Fearnley Street/Fall Lane/Brooks
Yard,
Westtown, Dewsbury, WF13 2SW
Stage 1 Road Safety Audit

CLIENT: P & S Consulting Engineers Limited
PROJECT TITLE: Fearnley Street/Fall Lane/Brooks Yard,
 Westtown, Dewsbury, WF13 2SW
REPORT TITLE: Stage 1 Road Safety Audit
PROJECT REFERENCE: 164318
DOCUMENT NUMBER: 002
ISSUE NUMBER: 01
DATE: January 2025

Report title:	Stage 1 Road Safety Audit
Date:	24 January 2025
Document reference and revision:	164318-002-01
Prepared by:	Sanderson Associates
On behalf of:	P & S Consulting Engineers Limited
Overseeing Organisation:	Kirklees Metropolitan Borough Council

Road Safety Audit St 1
Marked up plan

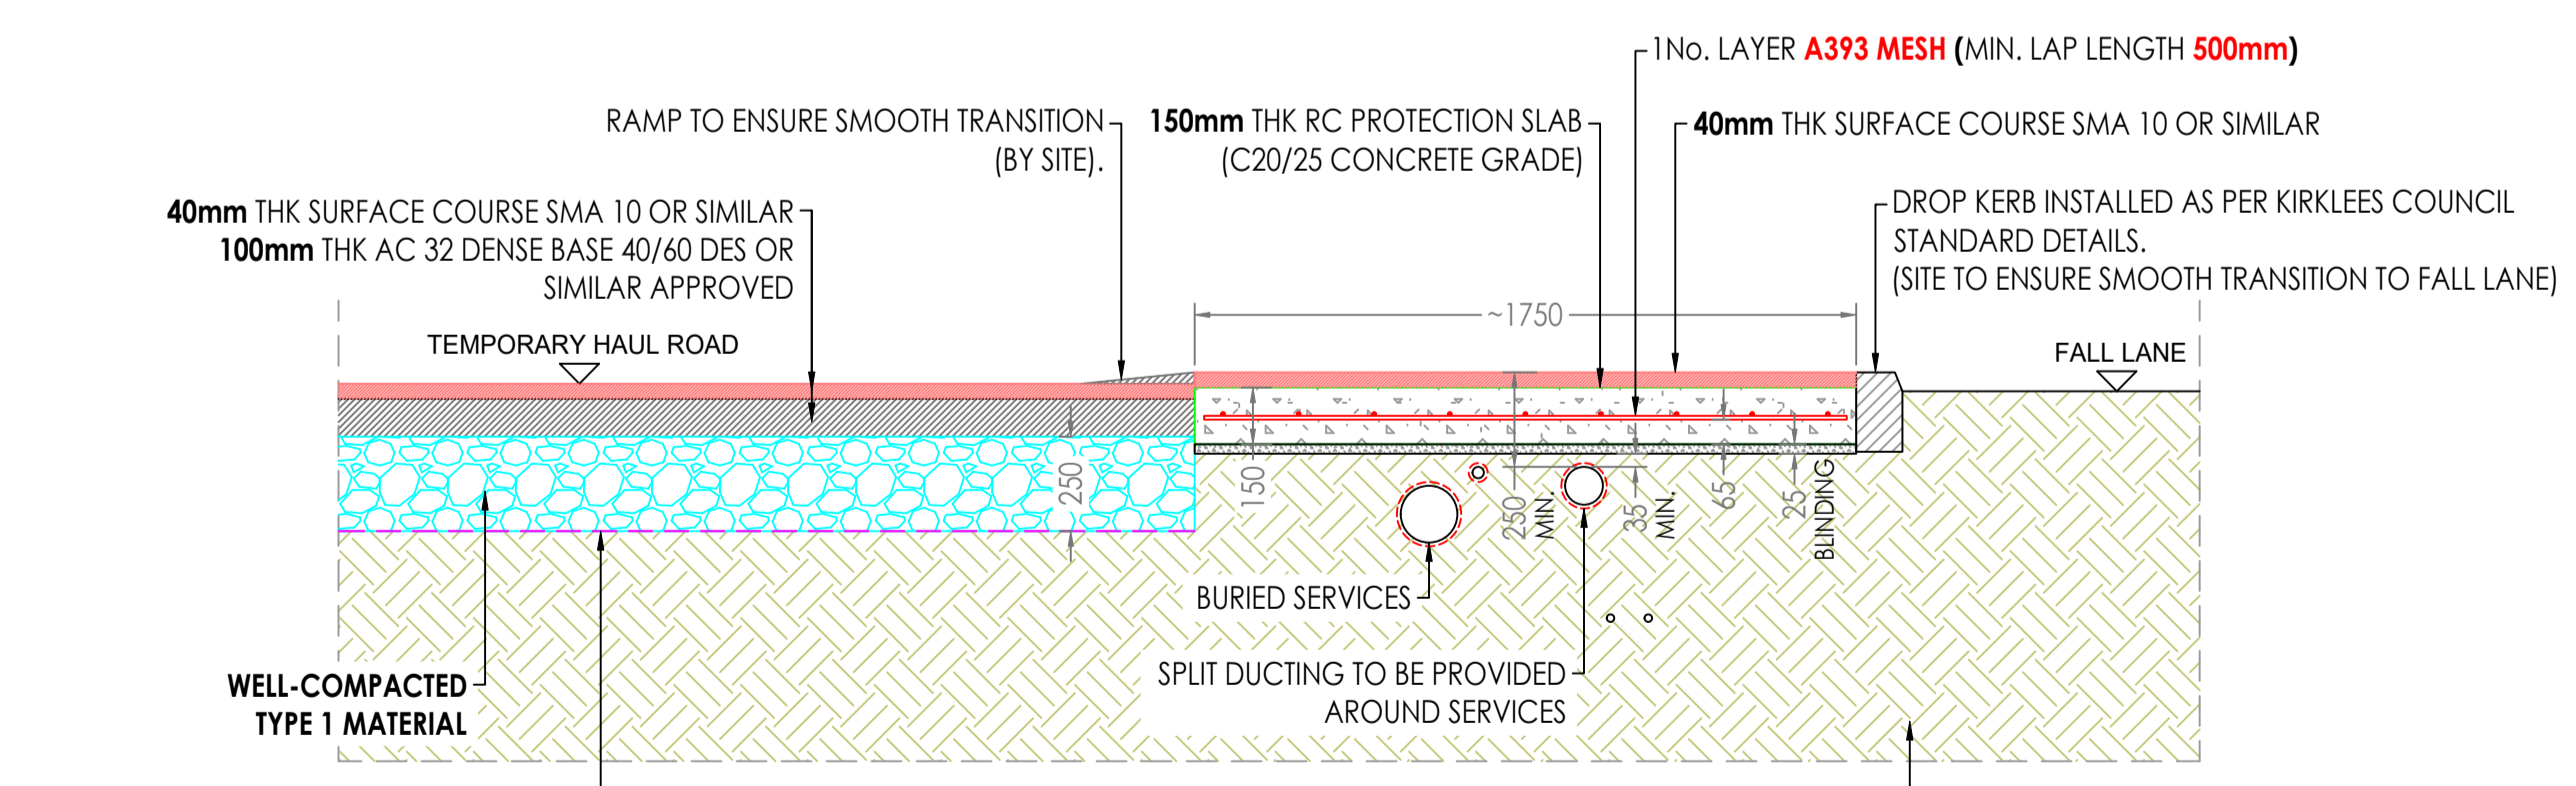
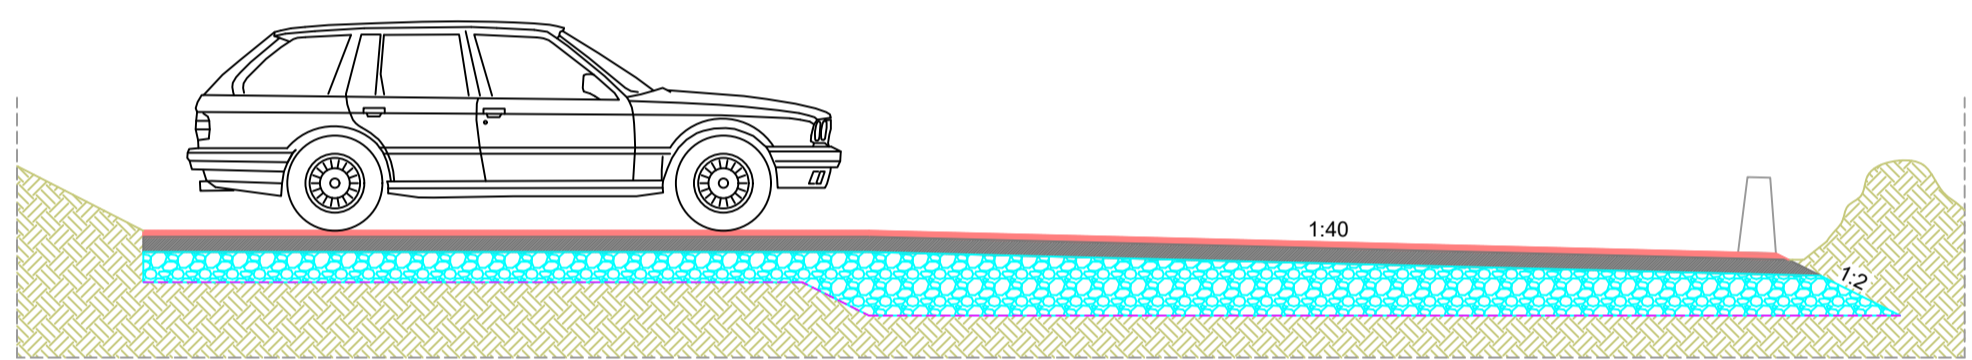
Summary: An ACO drain has been shown to intercept surface water on the haul road running over the footway and into the carriageway but details of the outfall are not shown.

Whilst it is recognised that this is a stage 1 RSA no details of the proposed surface drainage outfall have been provided. The concern is that if adequate drainage is not provided it could lead to skid or loss of control incidents in the carriageway during periods of inclement weather and where vehicles could be braking to negotiate the traffic signal junction (when in operation).

Summary: An ACO drain has been shown along Fearnley Street across the haul road to intercept surface water running from it but no details of the outfall are shown. Construction work for the Fall Lane road realignment is well advanced and the proposed works would cross Fearnley St. However, at the time of the site visit Fearnley St was being used for the connection to Fall Lane whilst the dropped footway crossover was being constructed at the end of the temporary haul road access.

Whilst it is recognised that this is a stage 1 RSA no details of the proposed surface drainage outfall have been provided to prevent surface water on the haul road (which slopes to Fearnley Street) running onto the carriageway. The next highway gully is at the Fearnley Street / Fall Lane junction. If this gully is not effective in intercepting all surface water and some could overshoot into Fall Lane where there is only one further gully before the signalised junction area. The concern is that if adequate drainage is not provided it could lead to skid or loss of control incidents in the carriageway during periods of inclement weather and where vehicles could be braking to negotiate the traffic signal junction (when in operation). It is recognised that Fearnley St will be cut by the new alignment with a new junction being provided as part of the permanent works.

Summary: Drawing 151667-TSA-W3B-MVL3-DRG-C-CV-000046 Rev. C3 shows the swept path of a 7.5tonne vehicle associated with deliveries to the Shepherds Boy public house although it appears to be closed. The swept path crosses into the contra flow cycle lane on the southern side of Fall Lane.

Traffic Management (TM) has now been installed on Fall Lane and Thornhill Road with the temporary haul road in use by residents. The current phase of Traffic Management is expected to be in place until June 2025. At the time of the site visit the new dropped kerb crossover was under construction and residents were using the original alignment of Fearnley St to join Fall Lane. The TM on Fall Lane comprises of tapered hatch markings up to the haul road to guide traffic away from the northern kerb line and the closed section of carriageway circa 1m wide further to the east. In addition, plastic bollards were to be provided along a new solid road marking separating the contraflow cycle lane. However, the plastic bollards had been removed as the temporary traffic management called for cyclists travelling in both directions to dismount and use the temporary pedestrian route. Whilst it is recognised that the public house is closed and Traffic Management is in place the concern is that if vehicles, similar in size to the 7.5t vehicle, needed to gain access it would have to cross the line of bollards, dislodging them creating a hazard for road users on Fall Lane and potentially into the path of cyclist. This could lead to sudden braking, skidding or loss of control incidents in the carriageway during periods of inclement weather or conflicts with cyclists.

Summary: The Temporary Haul Road joins Fall Lane where it is one way and users of the Temporary Haul Road would have to turn left only in the same manner as the existing Fearnley Street junction.

The concern is that if a vehicle was to try and turn right it would do so head on in to traffic proceeding from the west in the correct direction of the one-way system. This could lead to head on collisions and sudden braking together with skidding or loss of control incidents in the carriageway during periods of inclement weather or conflicts with contra flow cyclists.

Recommendation: provide appropriate drainage and outfall to intercept surface water before it discharges off the haul road into the carriageway. It should be ensured that the existing gully just to the west is in effective working order.

Recommendation: Provide appropriate drainage and outfall to intercept surface water before it discharges off the haul road / Fearnley Street into the Fall Lane carriageway. It should be ensured that the existing gullies on Fearnley Street and Fall Lane are in effective working order until Fearnley St is cut by the new junction works.

Recommendation: Manage the egress of larger vehicles and turning into the TM lane together with temporary removal and replacement of the bollards.

Recommendation: provide appropriate road markings and signage to direct drivers to turn left out of the Temporary Haul Road.
